SERVICE BULLETIN

SB651

SUBJECT: CAPACITOR INFORMATION AND INSTALLATION FOR D-2000 AND D-3000 SERIES MAGNETOS.

REASON FOR BULLETIN: To provide information and instructions when troubleshooting difficulties associated with capacitors in the D-2000 and D-3000 Series Magnetos, and to provide revised installation instructions for these capacitors.

FIGURE 1
TYPICAL D-2000 / D-3000 CAPACITOR

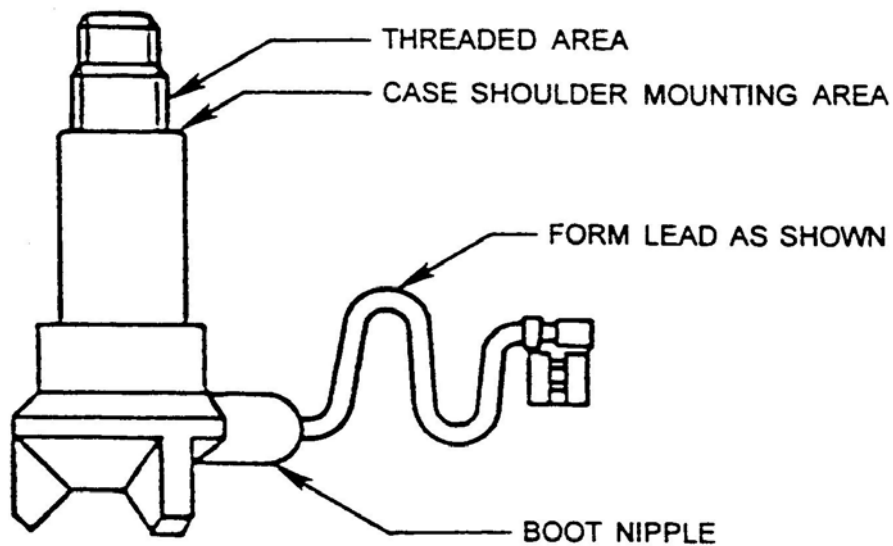
In the D-2000 and D-3000 Series Magnetos, the capacitor ground return path begins at the capacitor case. The capacitor case has a threaded area for a nut and a lockwasher to fasten the capacitor to the harness cover. The cover is then fastened to the magneto housing by four hold-down screws, allowing a ground return path through the housing-to-cover mating surfaces as well as through these screws. Original Bendix and TCM D-2000/D-3000 harness covers and all D-2000 and D-3000 Series Magneto housings are made from a magnesium alloy. Improper application of surface treatments, paints, thread locking compounds, brightening materials, gasket materials, and threaded fastener torque, singularly or in combination, can cause the capacitor to become insulated from magneto ground. Likewise, given enough time without the required preventive maintenance, the effects of moisture, heat, contamination, and a corrosive environment can serve to insulate the capacitor from magneto ground.

- b. Ensure capacitor mounting surface inside the harness cover is clean and free of corrosion. If necessary, brighten harness cover in the inside capacitor mounting area with ONLY a clean, fresh nylon scouring pad.
- c. Using ONLY a different clean fresh nylon scouring pad, remove contamination and corrosion from capacitor case shoulder and threads as necessary. See Figure 1
- d. Form capacitor leads as shown in Figure 1.
- e. Install the two capacitors in their respective places in the harness cover. Secure each capacitor with lockwasher and nut, centering the boot nipple between the harness silicone grommets. Apply 60 to 70 inch pounds torque to each nut. NOTE... To ensure correct alignment of capacitor boot nipple, the harness cover and capacitor may be temporarily mounted onto a magneto while the capacitor securing nut is tightened.
